UNITED STATES PATENT AND TRADEMARK OFFICE

APPLICATION NO.	FILING DATE	FIRST NAMED INVENTOR	ATTORNEY DOCKET NO.	CONFIRMATION NO.
09/736,651	12/13/2000	Bart Dierickx	522-1729	8263
23644	7590	09/19/2005	EXAMINER	
BARNES & THORNBURG P.O. BOX 2786 CHICAGO, IL 60690-2786			LEE, EUGENE	
			ART UNIT	PAPER NUMBER
			2815

Office Action Summary	Application No.		Applicant(s)	
	09/736,651		DIERICKX, BART	
	Examiner		Art Unit	
	Eugene Lee		2815

DETAILED ACTION

FIG. 5

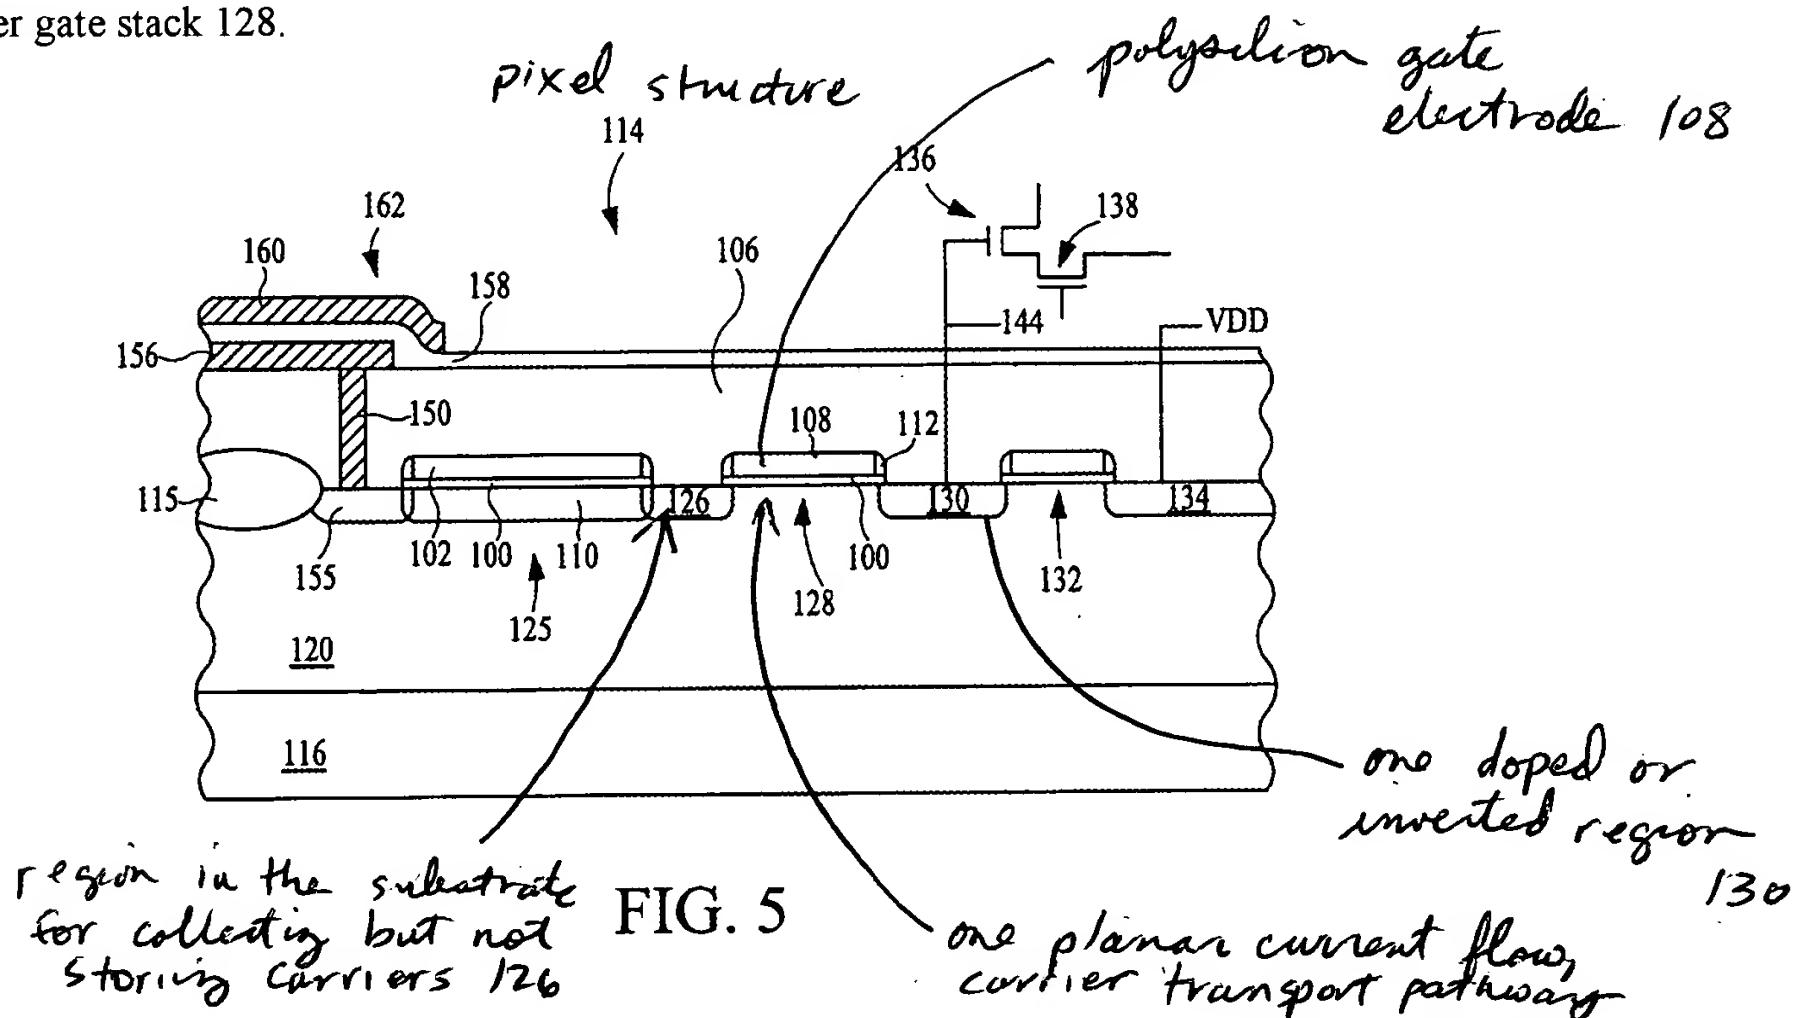
3. Claims 1, 7, 8, and 10 are rejected under 35 U.S.C. 102(e) as being anticipated by Rhodes 6,204,524. Rhodes discloses (see, for example, FIG. 5) a pixel cell (pixel structure) 114 comprising a substrate, radiation sensitive source of carriers in the substrate, transfer region (region in the substrate for collecting but not storing carriers) 126, floating region of a second conductivity type (one doped or inverted region) 130, and one planar current flow, carrier transport pathway.

Regarding the limitation "wherein the region for collecting but not storing carriers is substrate under a polysilicon gate electrode", see column 8, lines 41-51 wherein Rhodes

discloses the conductive layer (polysilicon gate electrode) 108 comprising polysilicon and part of transfer gate stack 128.

Regarding the limitation “a region in the substrate for collecting but not storing carriers”, Rhodes discloses (see, for example, column 9, lines 19-23) the transfer region 126 having a dopant concentration of 1×10^{15} ions/cm² – 1×10^{16} ions/cm². On page 7, lines 26-33, the applicant discloses the concentration of the carrier collecting region 3 being 1 to 2×10^{16} /cm² wherein such a low concentration means that no free charges are available, i.e. no storage of charge.

Regarding claim 8, see, for example, FIG. 5 wherein Rhodes discloses doped region (at least one implant) 110.

5. Claim 9 is rejected under 35 U.S.C. 103(a) as being unpatentable over Rhodes '524 B1 as applied to claims 1, 7, 8, and 10 above, and further in view of Baukus et al. 5,973,375. Rhodes discloses (see, for example, FIG. 5) a field oxide layer (field oxide) 115. Rhodes does not disclose regions of a second conductivity type in or on the substrate avoiding touching of the region for collecting but not storing carriers and a field oxide. However, Baukus discloses (see, for example, FIG. 11) a semiconductor device comprising a buried layer 70. In column 9, lines 41-46, Baukus discloses the buried layer inhibiting current flow between regions. Therefore, it would have been obvious to one of ordinary skill in the art at the time of invention to have regions of a second conductivity type in or on the substrate avoiding touching of the region for collecting but not storing carriers and a field oxide in order to inhibit current flow between regions.

under a polysilicon gate, this argument is not persuasive. In FIG. 5, Rhodes clearly discloses the region 126 under the polysilicon gate electrode 108. In Webster's Collegiate Dictionary, the word "under" is defined as 1 : in or into a position below or beneath something. Clearly, the region 126 is into a position below the polysilicon gate electrode as the edge of region 126 is under the polysilicon gate electrode 108.
